P5020A-03-S

Safety Service Note

P5020A Keysight Streamline USB Vector Network Analyzer

“POTENTIAL BURN INJURY (HIGH TEMPERATURE) HAZARD”

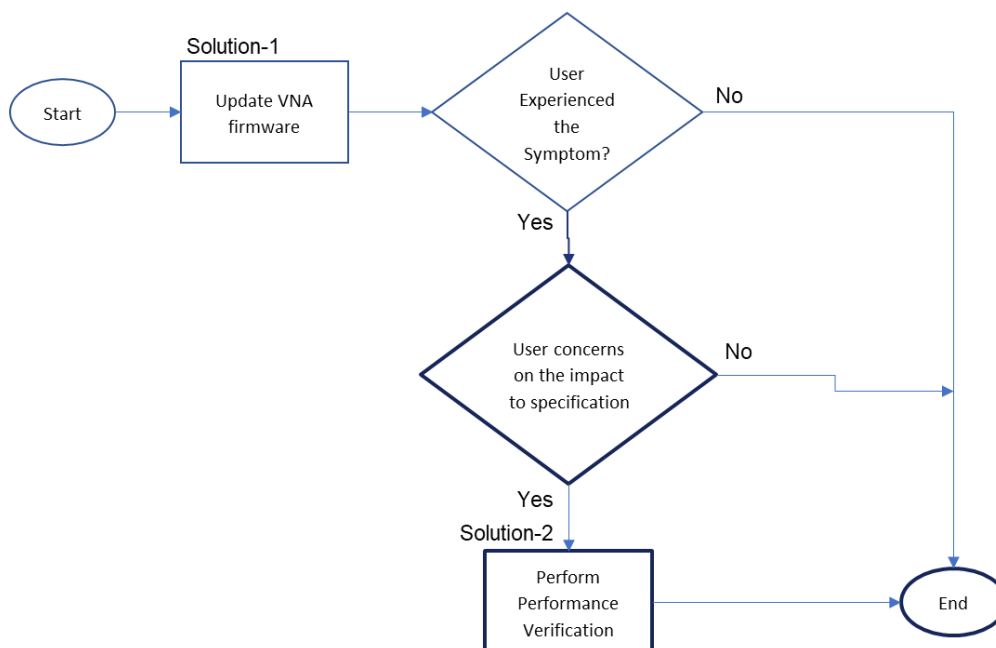
Symptom:

VNA fails to start with the following symptoms.

1. LED indicator (below circle) turns red.
2. cooling fan does not work
3. If user leaves the VNA with this LED indicator red without turning off power switch, it continues to overheat and becomes too hot.

Solution-1: Update VNA firmware by user

Action-1: Updating the firmware eliminates this potential risk of overheating.

1. **Install the latest VNA firmware Rev. A.15.40.13 or newer** on users' controller PC(s).
The latest firmware enhanced the thermal fan control mechanism.
2. Once the latest firmware is installed, proceed with the restart of both **controller PC** and **VNA**.
3. Launch the VNA firmware. Ensure VNA powers up and launches into firmware correctly after firmware update is done.
